**PIC18F6627/6722/8627/8722**

**PIC18F6627/6722/8627/8722 Rev. A1 Silicon Errata**

**The following silicon errata apply only to PIC18F6627/6722/8627/8722 devices with these Device/Revision IDs:**

**FIGURE 1: SCKx PULSE VARIATION USING TIMER2/2**

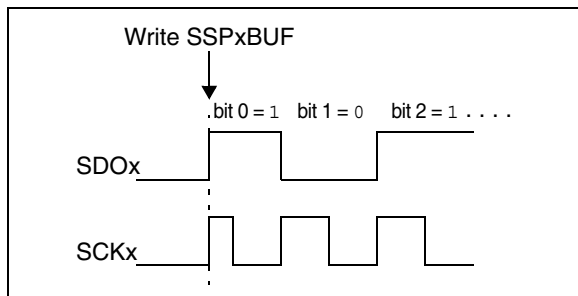
When the SPI is using Timer2/2 as the clock source, a shorter than expected SCKx pulse may occur on the first bit of the transmitted/received data (Figure 1).

To avoid producing the short pulse, turn off Timer2 and clear the TMR2 register, load the SSPxBUF with the data to transmit and then turn Timer2 back on. Refer to Example 4 for sample code.
